Assessment of solar PV and battery storage proposals for South Wonston Pavilion

Prepared for: South Wonston Parish Council

Prepared by: Richard Mould-Ryan t/a SO Solar Advice, 30 Chapel Road, West End, Southampton SO30 3FN.

Date: 7th May 2026

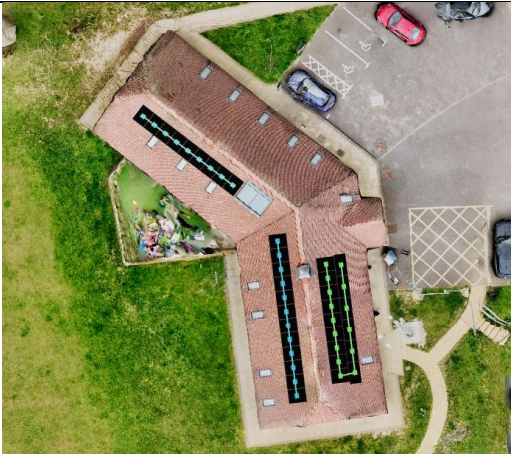
The south-west facing array of 10 panels from C2's 35 panels will not fit into the space available as can be seen from the images below; only 9 panels can fit into this space and if the Council is minded to accept their proposal this should be clarified and confirmed, and the total output would be slightly lower as a result. The longer east facing array might require planning permission even if its position is adjusted, and the in-roof system might also require planning permission due to the additional space taken up by the trays and flashing system.
